VKBD 0155

Technical Bulletin – December 2015

FORD: ESCORT VII, KA

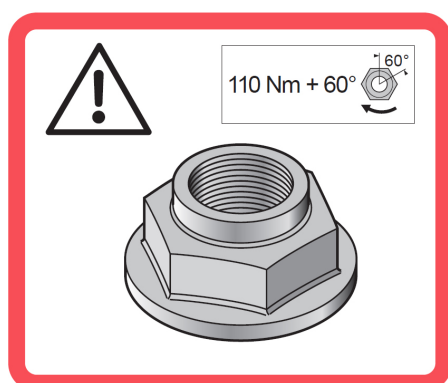
SKF has decided to change the nut in VKBD 0155, due to updated FORD OE recommendations.

Note: The included nut at kit VKBD 0155 has a new design and needs a different torque compared to the old design. It is crucial to follow the instructions when torquing the new nut since this is a **safety aspect**. See torque values stated at the warning label below.

New design

Old design

Caution, when fitting the wheel bearing kit VKBD 0155, it's mandatory to use the new nut included in the kit. Never reuse an old nut!
